## V2500-A5 SERIES PROPULSION SYSTEM SERVICE BULLETIN

This document transmits the Revision 1 of Service Bulletin V2500-ENG-72-0562.

## V2500-ENG-72-0562

ENGINE – HIGH PRESSURE TURBINE (HPT) – V2500 SELECTONE PRODUCTION AND RETROFIT – HPT  
UPGRADE

NOZZLE GROUP  
FIGURE 2

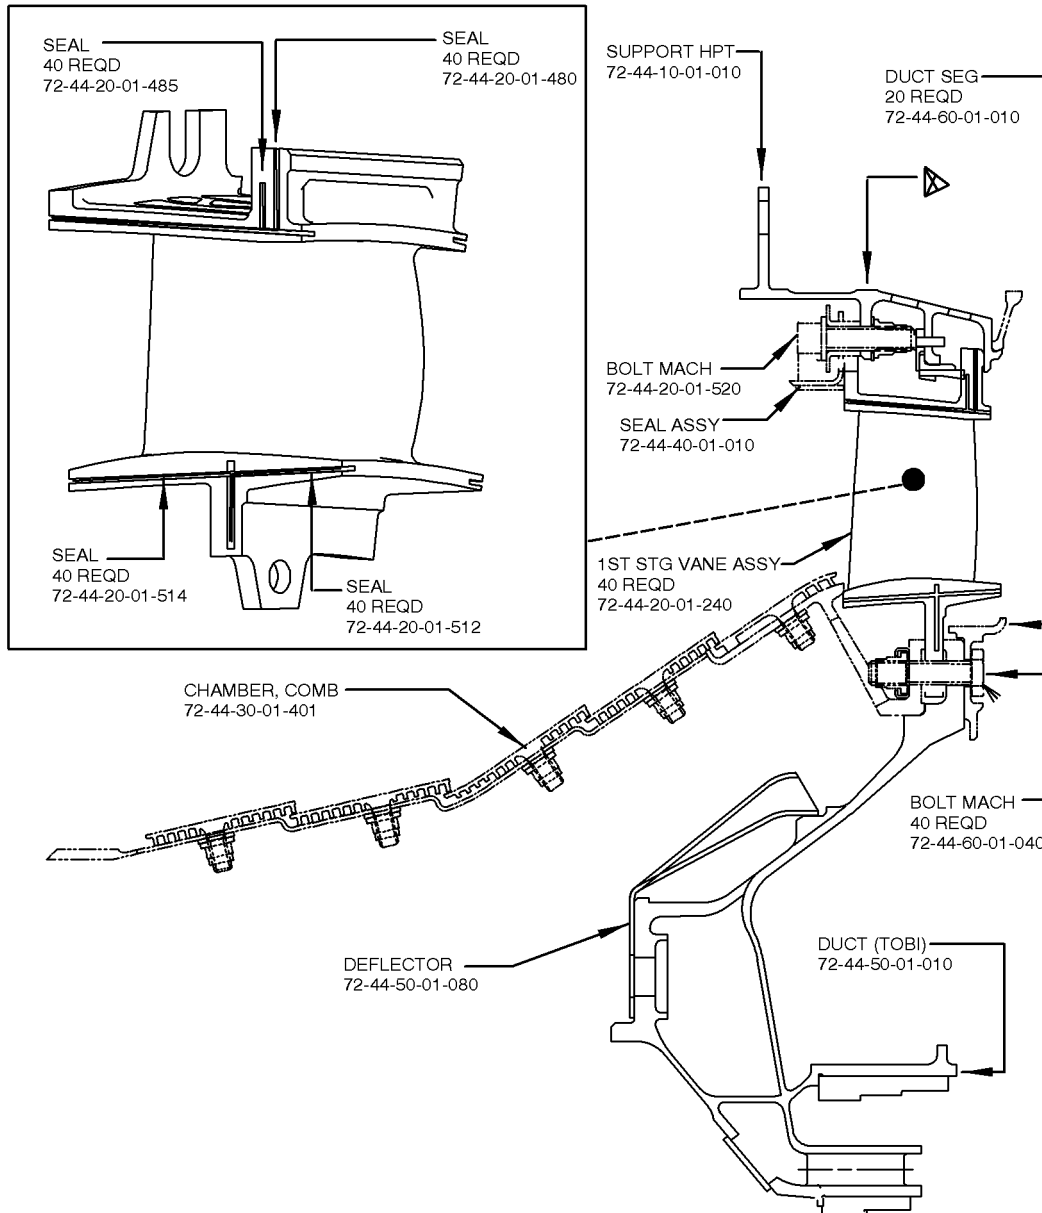
- R (i) Remove and discard the HPT Support in accordance with Reference 20, Engine Manual, Task 72-44-00-01-001. See Figure 2.
- R (ii) Replace the HPT Support Assembly with PN 2A4085, or later  
R approved parts.

See Figure 2 for the area to mark the part. Reidentify the part as shown in Table II.

DUCT (TOBI) RE-OP - FORWARD LOOKING REAR  
FIGURE 3

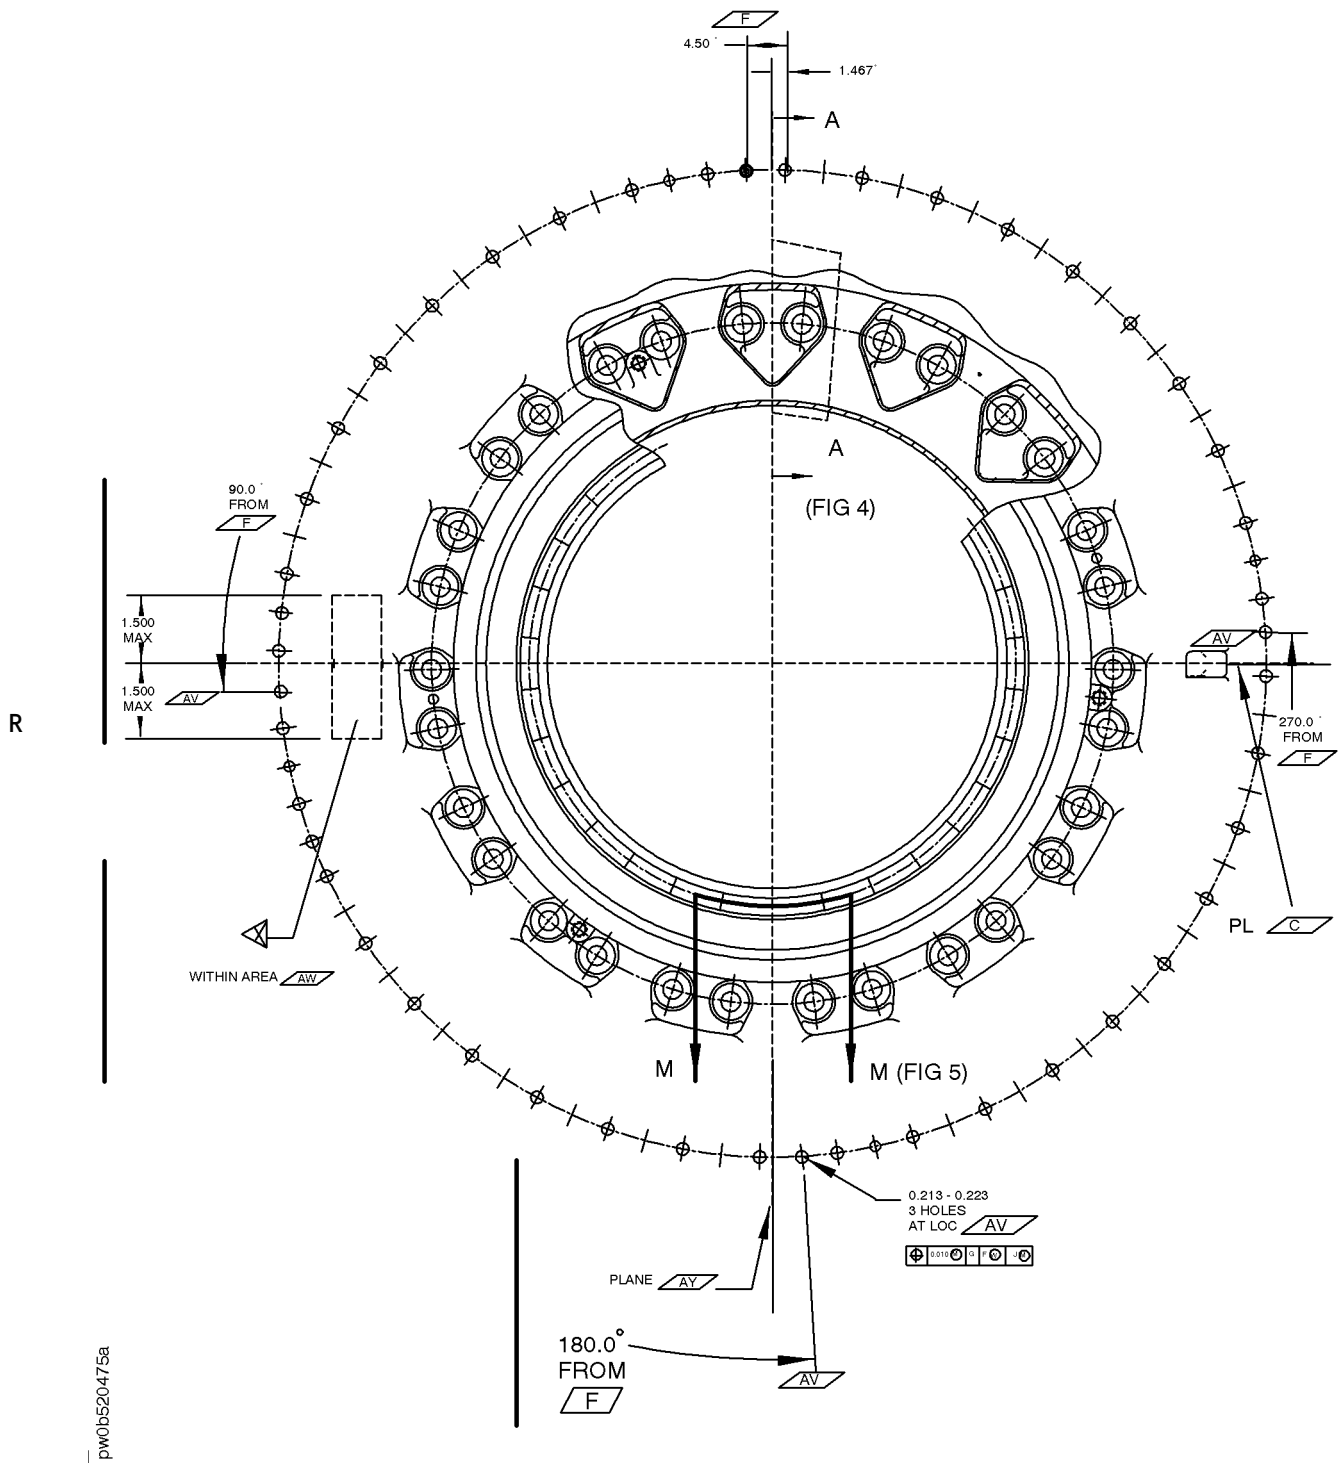
- R (4) For PN 2A3487-01, add 3 machine holes 0.213 to 0.223 in.  
R (5,41 to 5,66 mm) at Location AV as shown in Figure 3.

- R (5) Flow test passages collectively in direction shown in Figure 5 and in accordance with Reference 20, Engine Manual, Task 72-44-50-300-010 with:
- R Flow = 1.108 and Minimum Pressure Ratio = 1.519 Maximum Pressure Ratio = 1.558
- R To achieve the required flow, it is permissible to cut back trailing edges of all vanes as shown in Figure 5, View N, or add plugs as necessary as shown in Figure 5, Sect M-M. Dimension AZ in Figure 5, between trailing edge of adjacent cutback vanes must be alike within 0.060 in. (1,524 mm). Refer to 72-44-50 Repair, VRS3177.
- R (6) Mark the 1st Stage HPT Duct Assy with the new part number in accordance with Reference 23, V2500-A5 Standard Practices Manual, Chapter/Section 70-09-00-400-501, Vibration Peen Manual or Mechanical 0.006 in. (0,152 mm) max.
- R See Figure 3 for the area to mark the part. Reidentify the part as shown in Table I.

HPT ROTOR AND STATOR  
FIGURE 6 (SHEET 1 OF 2)

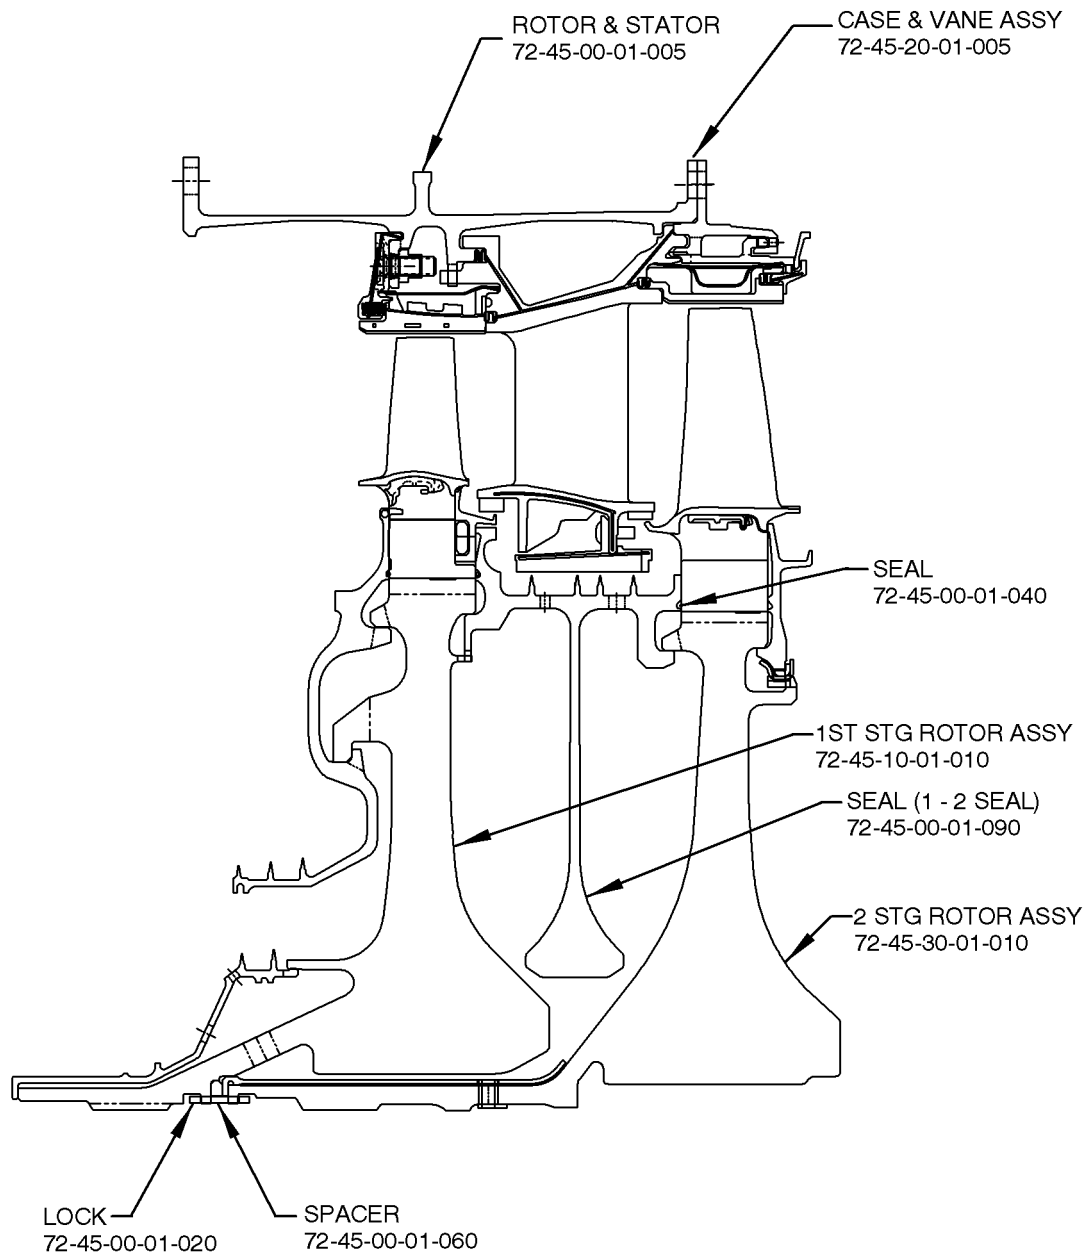
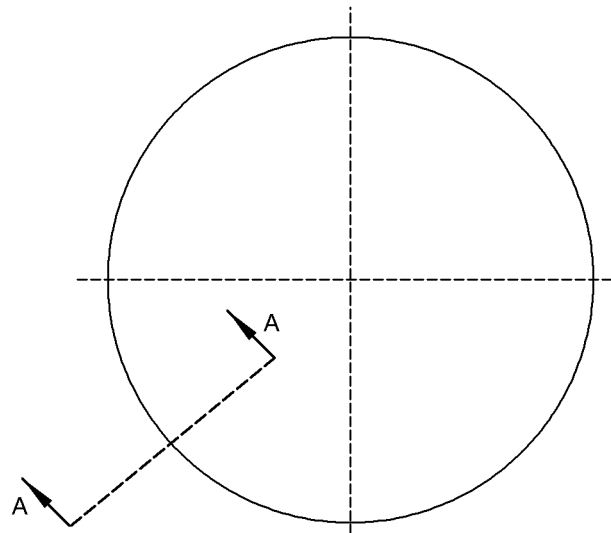
(b) Modify the HPT Rotor and Stator Assembly in accordance with Reference 20, Engine Manual, Task 72-45-00-01-001. See Figure 6A.

HPT ROTOR AND STATOR  
FIGURE 6 (SHEET 2 OF 2)

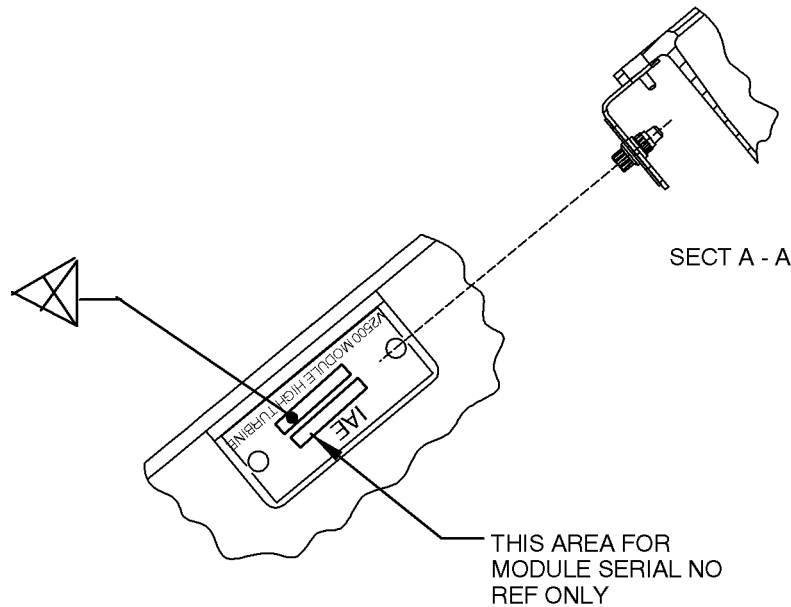
See Figure 6B for the area to mark the part. Reidentify the part as shown in Table V.

HPT CASE AND VANE ASSEMBLY  
FIGURE 7

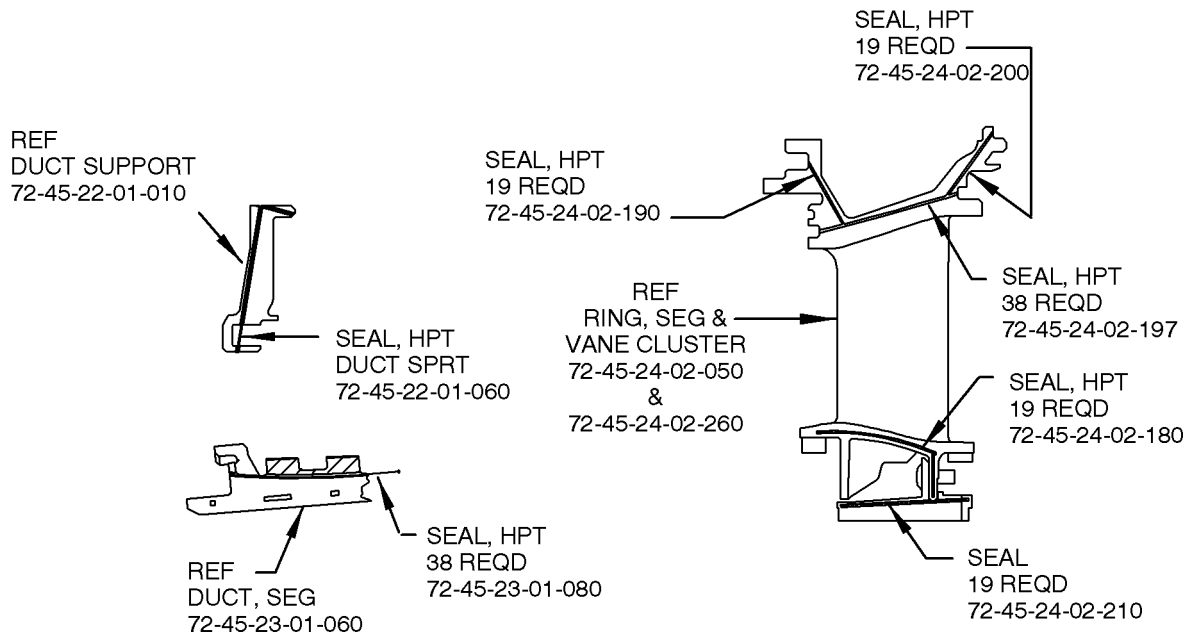
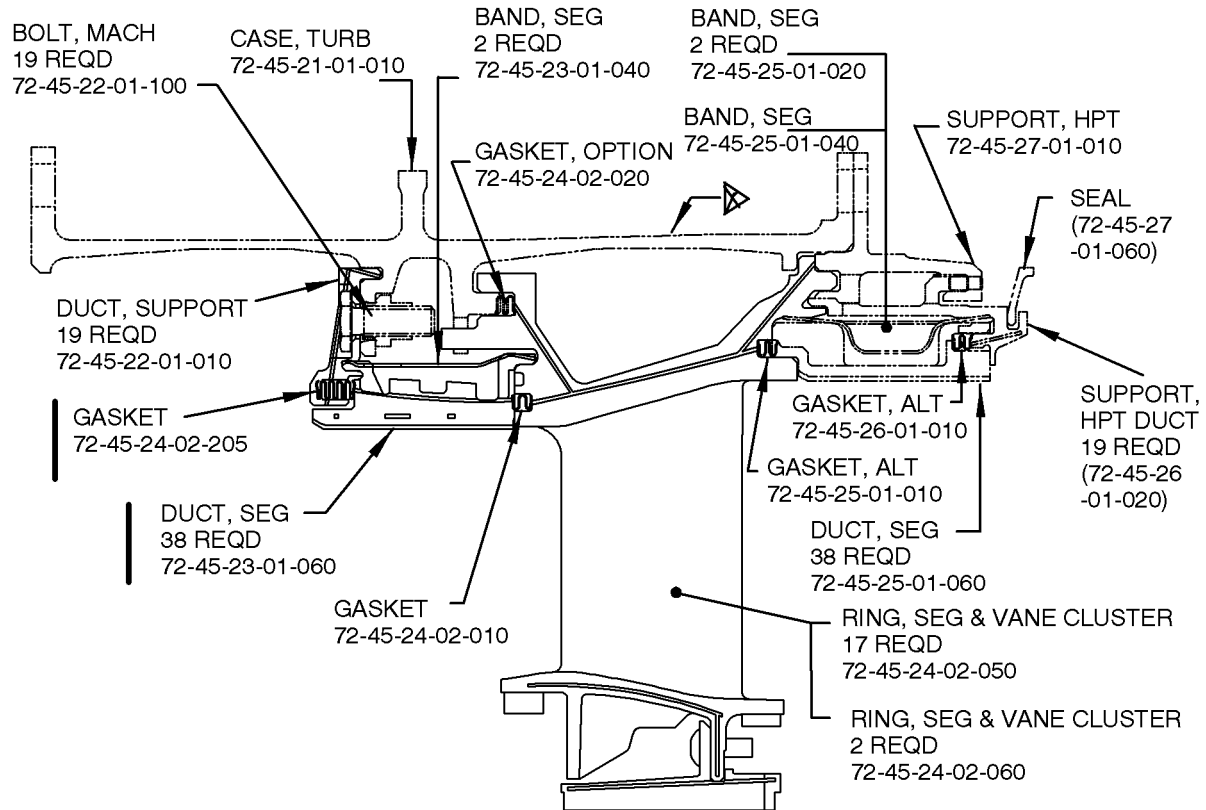
- R (c) Modify the HPT Case and Vane Assembly (ATA 72-45-20-01-005):
- R (i) Disassemble the HPT Case and Vane Assembly (ATA 72-45-20-040-001-C00).
- (ii) Remove, discard and replace the Ring Segment and Vane Cluster.

- (1) Remove 2nd Vane Cluster and Ring Segments (17) Standard (ATA 72-45-24-02-050) and replace with PN 2A4262.
- (2) Remove 2nd Vane Cluster (2) (ATA 72-45-24-02-260) and replace with PN 2A4162.

- (iii) Remove and discard the Duct Support (19). Reference ATA 72-45-22-01-010.
- (iv) Replace Duct Support (19) with PN 2A4130.
- (v) Remove and discard the HPT Seal (38). Reference ATA 72-45-23-01-060.

See Figure 7 for the area to mark the part. Reidentify the part as shown in Table VI.

HPT 1ST STAGE TURBINE ROTOR  
FIGURE 8

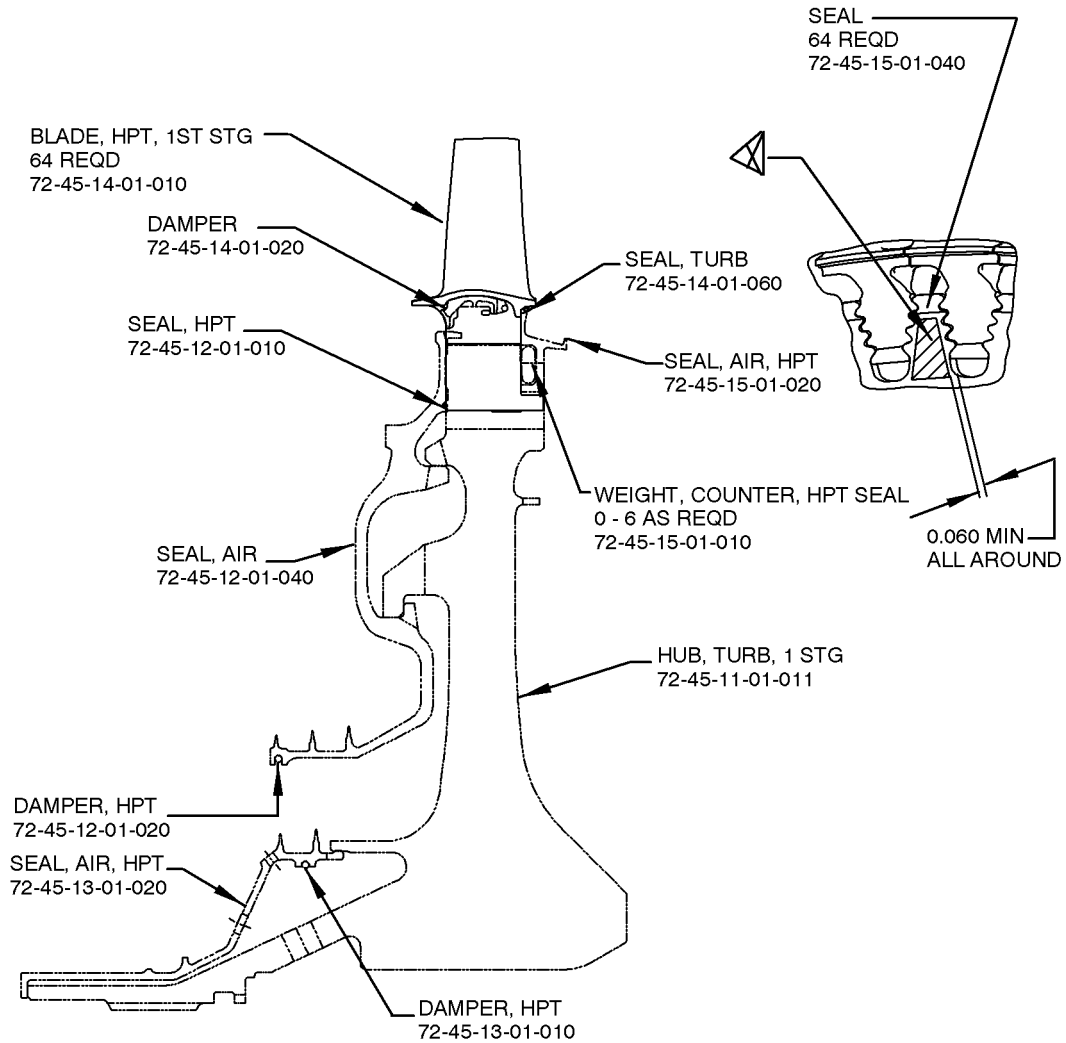
- R (iii) Remove and discard the 1st Stage Rotor Assembly in accordance with Reference 20, Engine Manual, Task 72-45-10-01-010.
- (iv) Replace the 1st Stage Rotor Assembly with PN 2A9921 or modify as follows:

- R (1) Remove and discard the 1st Stage Blade (64) in accordance with Reference 20, Engine Manual, Task 72-45-14-01-010.
- (2) Replace the 1st Stage Blade (64) with PN 2A9721.

See Figure 8 for the area to mark the part. Reidentify the part as shown in Table III.

HPT 2ND STAGE TURBINE ROTOR  
FIGURE 9

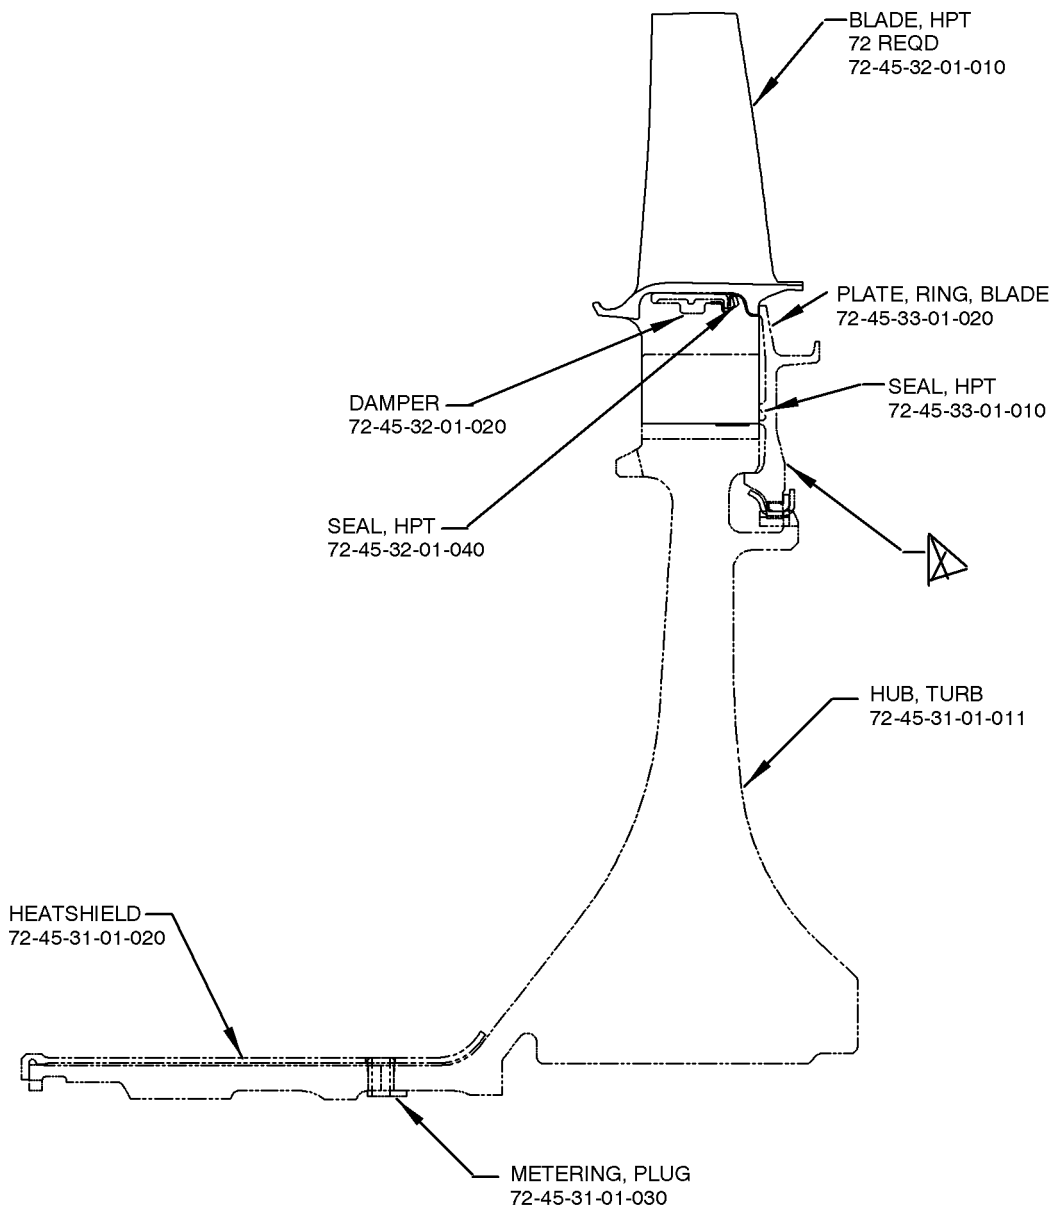
(v) Remove and discard the 2nd Stage Rotor Assembly in accordance with Reference 20, Engine Manual, Task 72-45-30-01-010.

(vi) Replace the 2nd Stage Rotor Assembly with PN 2A4522 or modify as follows:

(1) Remove and discard the 2nd Stage Blade (72) in accordance with Reference 20, Engine Manual, Task 72-45-32-01-010.

(2) Replace the 2nd Stage Blade (72) with PN 2A4422.

See Figure 9 for the area to mark the part. Reidentify the part as shown in Table IV.
